**Economic Commission for Europe**  
**Inland Transport Committee**  
**World Forum for Harmonization of Vehicle Regulations**  
**Working Party on Pollution and Energy**  
**Eighty-second session**  
Geneva, 12–15 January 2021

**Report of the Working Party on Pollution and Energy  
(GRPE) on its eighty-second session**

**Addendum 1**

## Proposal for a new series of amendments to UN Regulation No. 49 (Emissions of compression ignition and positive ignition (LPG and CNG) engines)

Figure 12

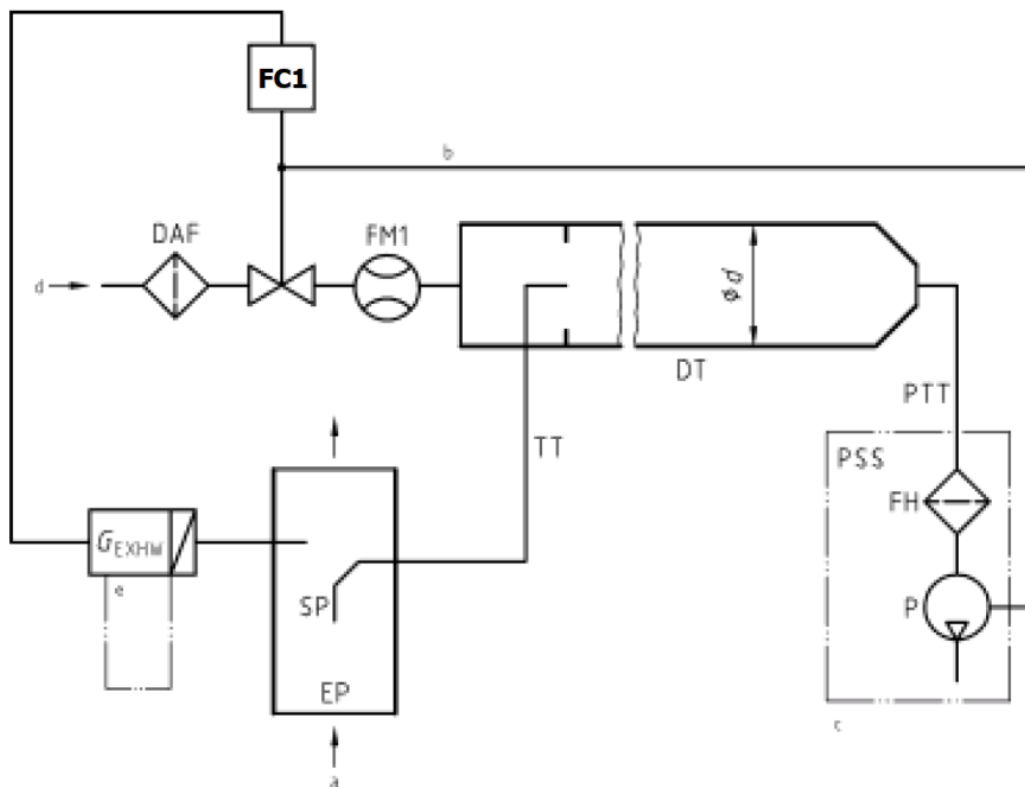
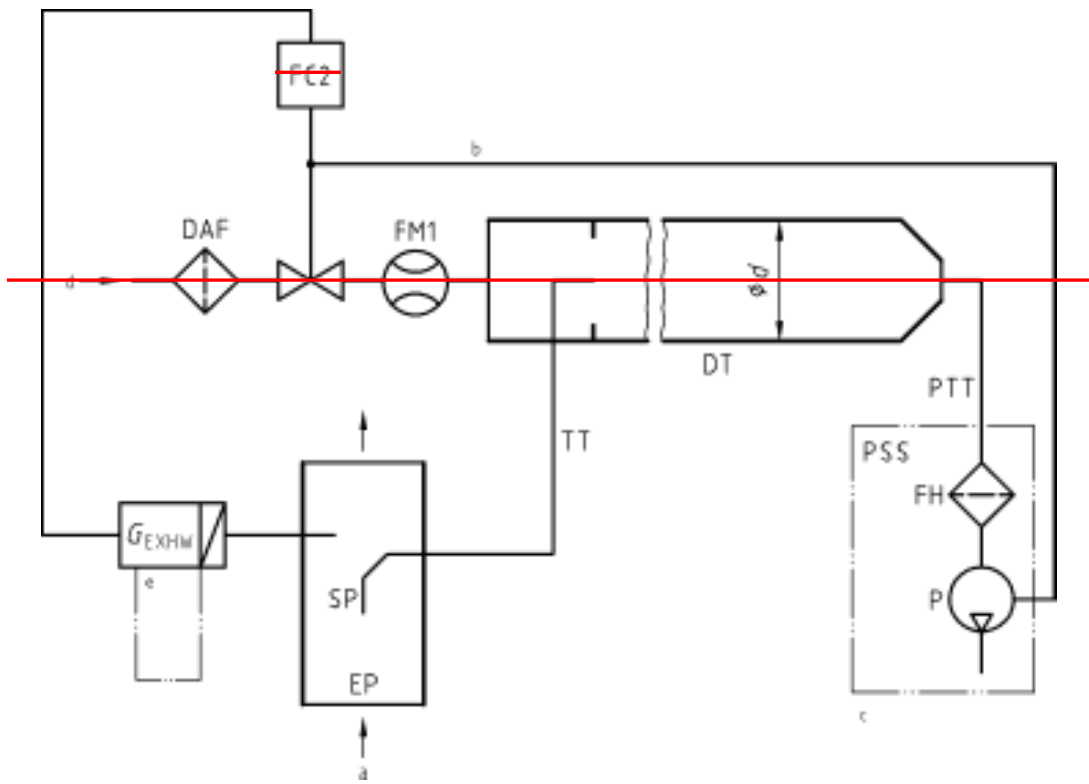
Paragraph A.2.2.1., amend to read:

Scheme of partial flow dilution system (total sampling type)

a = exhaust      b = optional      c = details see Figure 16  
 ..."

Figure 1  
Example of a PM number analyser setup

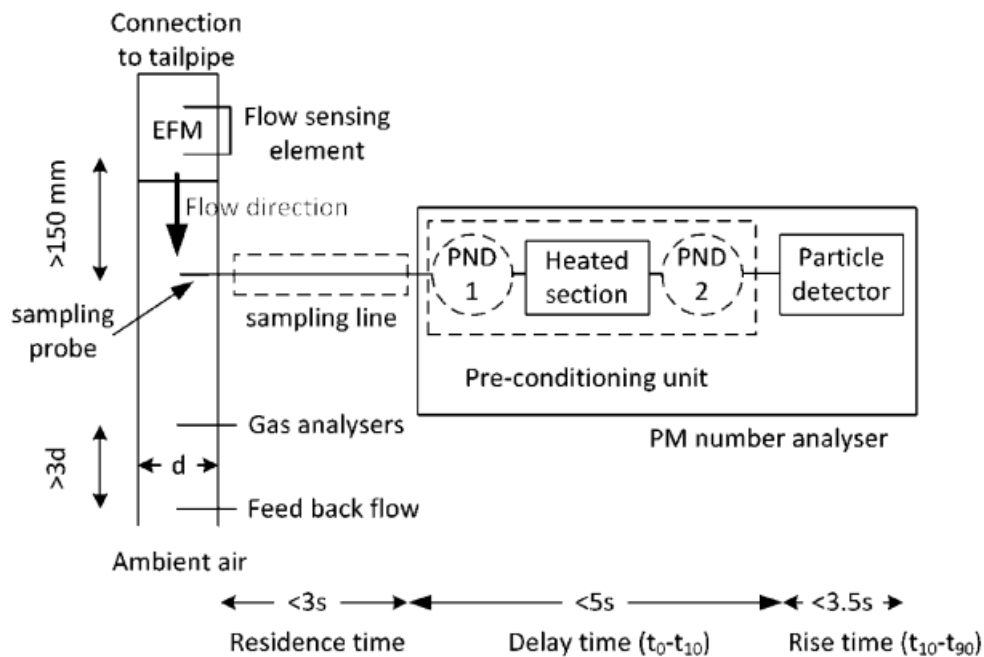
- A.2.2.5.1.1. The PM number analyser shall consist of a pre-conditioning unit and a particle detector (see Figure 1). The particle detector may also pre-condition the aerosol. The analyser's sensitivity to shocks, vibrations, aging, variations in temperature and air pressure, electromagnetic interferences and other things that could affect the operation of the vehicle or the analyser shall be kept to a minimum as far as possible and shall be clearly stated in the supporting documentation produced by the instrument manufacturer. The PM number analyser shall fulfil the requirements of this Regulation and the specifications of the instrument manufacturer.
